Town of Parker Community Development Department  
Development Review Division  
Attention: **Krista Flynt**

Application Type: **Site Plan**  
Status: **First Referral**  
Application Name: **Parker and Pine F1 L6 – Everbrook Daycare**  
Case/AP#: **SP20-058**  
Referral Received: January 29, 2021  
Comments Due: February 23, 2021

Review date: **February 16, 2021**  
Plan reviewer: **Randall L. Capra, [rcapra@parkeronline.org](mailto:rcapra@parkeronline.org)**  
Phone: 303.805.3169

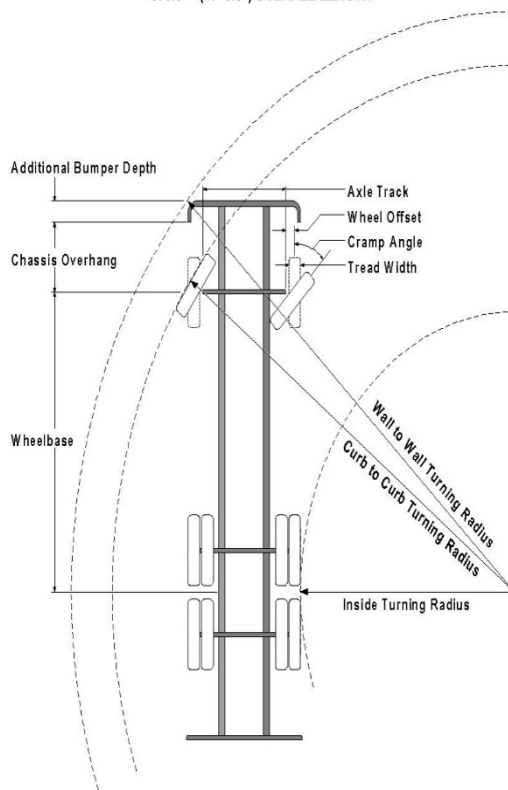
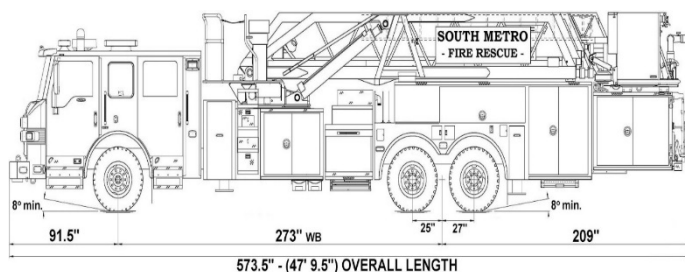
4. The applicant shall be aware that the access road hydrant distribution was not planned to address the suppression needs for all commercial properties within this subdivision; this site requires the addition of one hydrant (to be located at the s/w corner island of the building... as required per NFPA 24 Section 7.2.3... see the snap shot of the red-lined fire hydrant location shown under item 4 below:
